Subject: Class II permissive change Request

FCC ID: U2BRL039RC6GS

Granted on: 01/25/2018

Picture

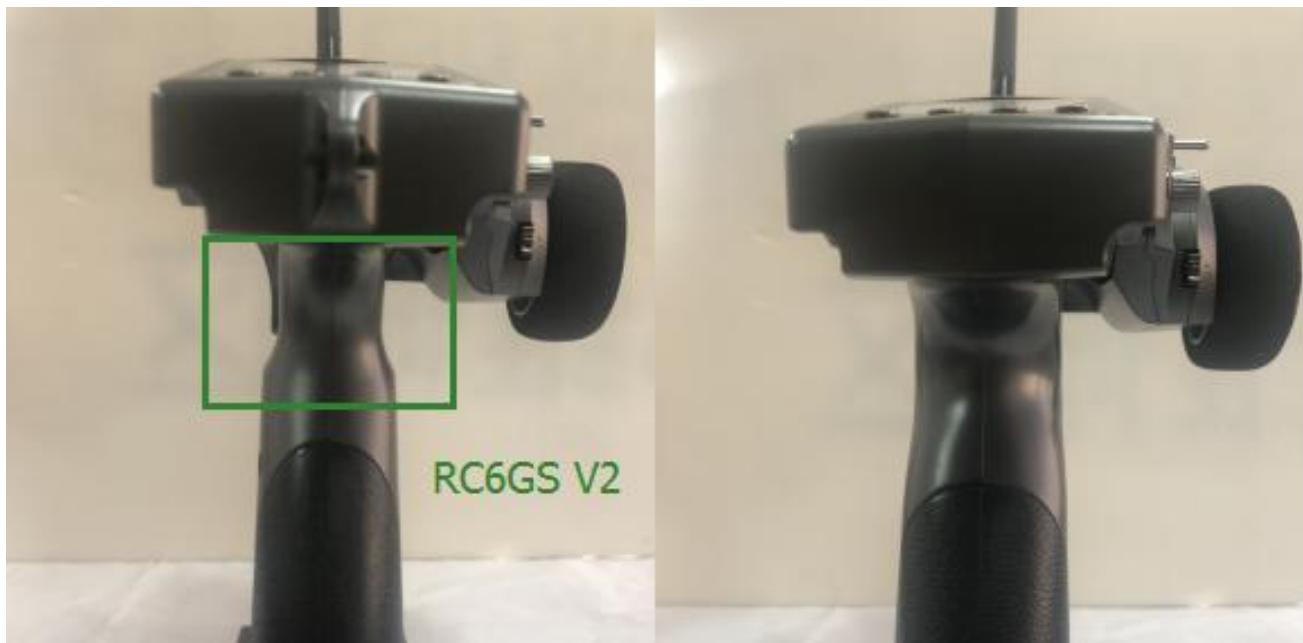
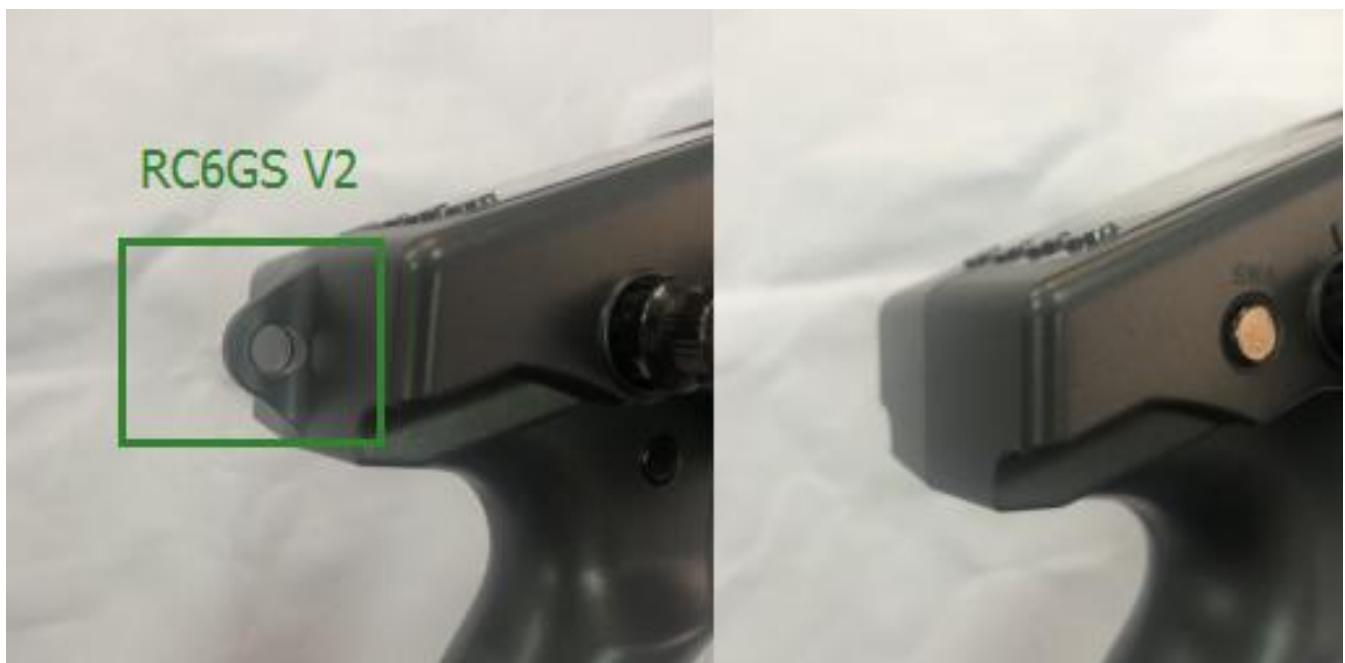
1. Appearance changes: The plastic parts of the trigger changed the design, the handle was changed from coarse to finer, 1 button changed position, 1 button added, and screw hole added. These appearance changes are to improve the feel and experience of use and will not affect the performance of RF. the differences in appearance are as follows.

2. Hardware change: The hardware version number is changed from REV: 01 to 2020: 4:30 REV: 01 and the differences in circuit diagrams as follows files.
